Appeal NO: ABP - 315708-23Defer Re O/H ☐

Your reference: 315708-23
Planning reference: 2250933, Donegal County Council

Case No: ABP-315708-23

Development Description: Demolition of existing concrete structure and quarrying of 5.37 hectares which will be subject to extraction and processing of rock through drilling, blasting, crushing and screening and all associated ancillary facilities/works over a 25 year period. An environmental impact assessment report and Natura impact statement accompanies this application.

Job Number 19280 Dwg Number 09

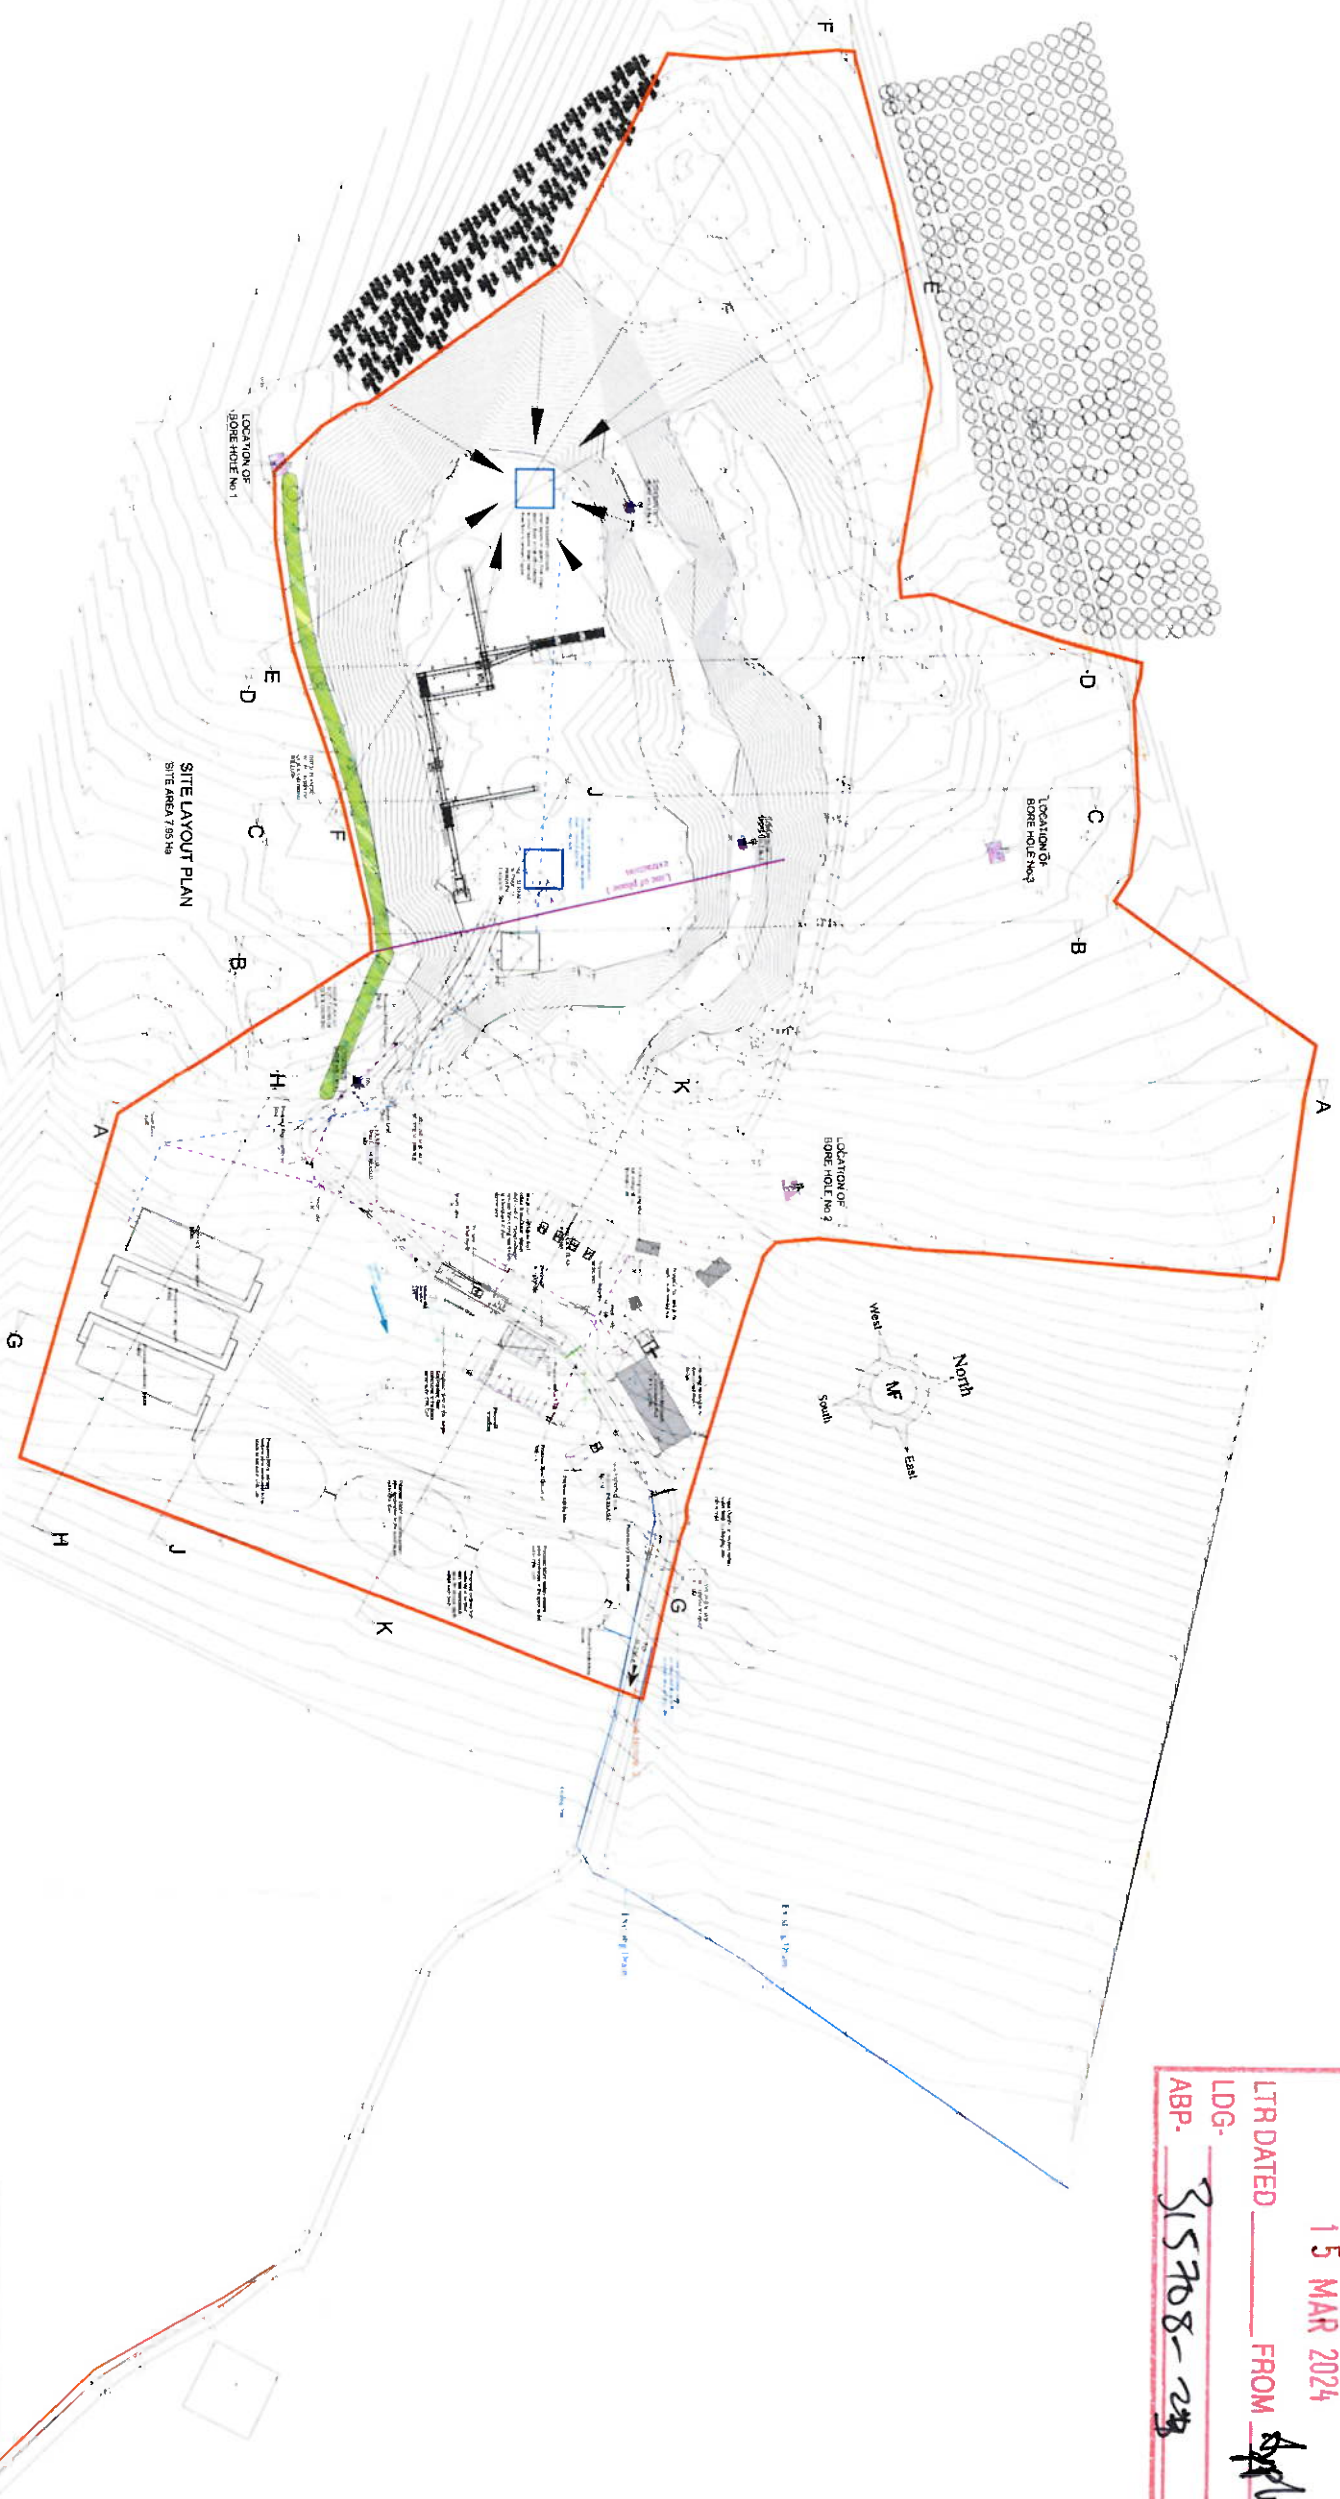
- **Please clarify the improvements proposed for the means of access to the site, i.e., the local road and its onward extension into the site, by means of a detailed site survey plan and elucidating cross-sections. This plan and there cross-sections shall indicate how the means of access would be drained and the relationship between it and the land drain, which would receive the discharge from the site. Any removal of existing vegetation to improve forward visibility shall be specified, too.**

Response: This is addressed in both the cover letter by Michael Friel (appendix 1) and the drawings in appendix 4; specifically drawing sheets 19280-09 (site layout), 19280-10 (site layout), 19280-21 (site sections), 19280-23 (realignment of junction at R236-6) & 19280-24 (passing bay road improvement layout) & site location drawing.

It is proposed to upgrade the road leading to the Quarry from the R-236 so as to ensure that the road is capable of dealing with the traffic which will be travelling to and from the Quarry as well as the existing traffic currently using the road. The upgrades will take the form of;

- Creating 4 No. lay bays along the road, which are long enough to facilitate an artic or rigid lorry pulling in and leaving the lay by again. The open drain will be piped at these locations using a twin wall 450mm pipe and stone will be placed on top of the pipe, compacted and a 50mm layer of stone mastic asphalt (SMA) will be laid before being finished with a layer of tar and chips which will be 10 mm stone interwoven with a 6mm stone to give grip and ensure the surface stays together for a longer period. Trees and hedges, common to the immediate area will be planted at the extremity of the layby's so as to give screening and so as to ensure that the works when complete are in keeping with the existing natural look along the roadway. As agreed with the roads section of the council, the upkeep of this road will be the responsibility of the Quarry operator if permission is granted, it is expected that periodic inspections will take place by the Local Authorities roads section so that any works which are necessary are agreed in advance of them taking place over the course of the operational phase of the Quarry facility.

- Rock Armour will be placed at locations, most likely in the form of rock placed in gabion cages as outlined on the site layout drawing to ensure that the road does not subside or slip in any way, the locations of the Rock armour placement has been agreed during a site meeting with the local roads Engineer, Mr. Tommy Doherty & Mr. Michael Canning Rod design team member.

Section T-T
Scale 1:200

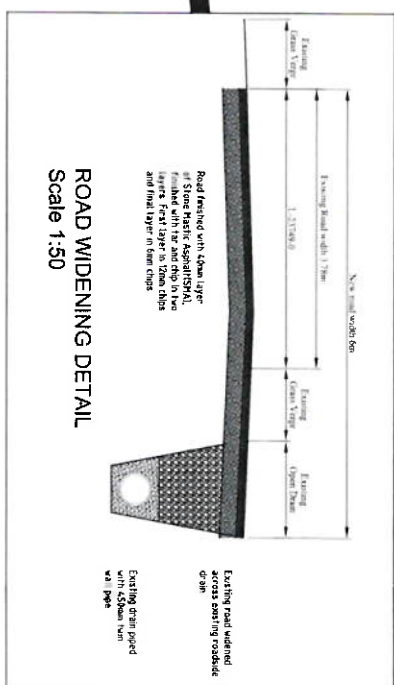
- **Please state the volumes of water that would discharge from the water management proposals into the land drain under normal and storm surge scenarios. Provide details of this drain, i.e., exact position, specification and condition, and demonstrate its adequacy to receive the envisaged discharge.**

A response to this point has been formulated by Greentrack Environmental Consultants and is included with this response by way of an attachment and deals with the normal and storm surge scenarios. I have also included a cross section of the drain for your perusal which shows the adequacy of same.

The discharge from the water management proposals is likely to vary from 0.4 l/sec to 9 l/sec. The land drain that the water management system proposes to discharge to is broadly triangular in cross-section with a flattened base.

The approx. cross-sectional area of the channel is 0.605 m² at bankfull. At maximum discharge, the contribution from the proposed development to the channel dimensions would approximate 1.5 % of the available channel cross section at a nominal water velocity of 1 m/sec. The land drain is therefore shown to have sufficient carrying capacity for the discharge from the proposal.
